TECH BULLETIN

005
08/77

SUBJECT: 10 Frame “B” Manifold and Stepped Valve Seat

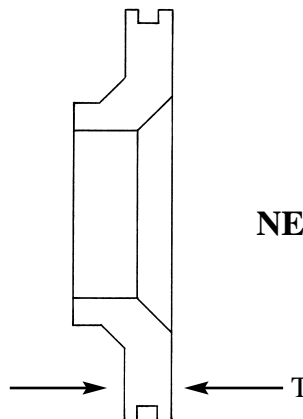
Beginning with May 1977, a back-up ring was added to the Valve Seat on all 10 Frame pumps. A thicker “stepped” Valve Seat was necessary to hold the added back-up ring and o-ring. A new manifold marked with a “B” with a deeper valve chamber was also necessary for this change.

OLD Valve Seat
T = .157" (4.0 mm)
PN 27350

NEW Stepped Valve Seat
T = .197" (5.0 mm)
PN 43046

It is important that parts are not interchanged from one design to another. However, with the use of PN 30452 spacer, the old Valve Seat with o-ring only may be used in the new style manifold-B.
